Bulletin No. 2002-20

▲ = Revised January 2003. This bulletin supercedes the previous bulletin 2002-20 November 2002.

Battery Wiring Requirements

- a - 12 Volt
- b - 24 Volt
- c - 36 Volt

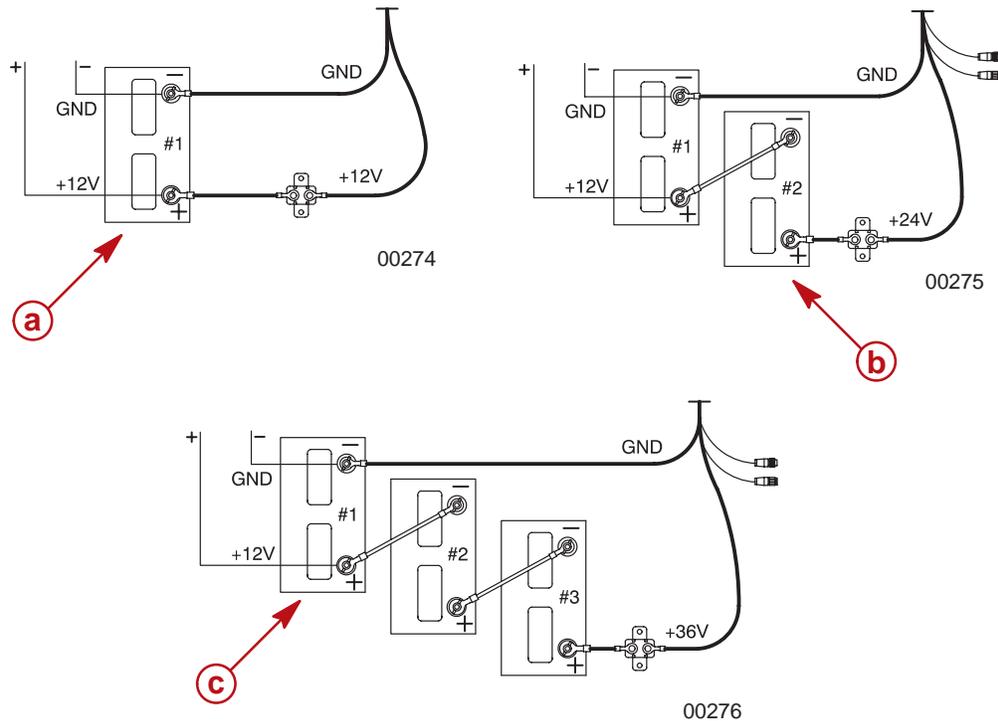
Utilizing the engine starting battery as a source of power for any trolling motor may cause electrolysis on metallic parts.

If electrolysis has occurred on a boat using a starting battery to power the trolling motor and cannot be resolved, remove the engine starting battery from the wiring configuration of the boat.

MotorGuide Marine recommends using a minimum of 13 mm² (6 gauge) battery cable whenever extending the length of the original leads provided with every trolling motor.
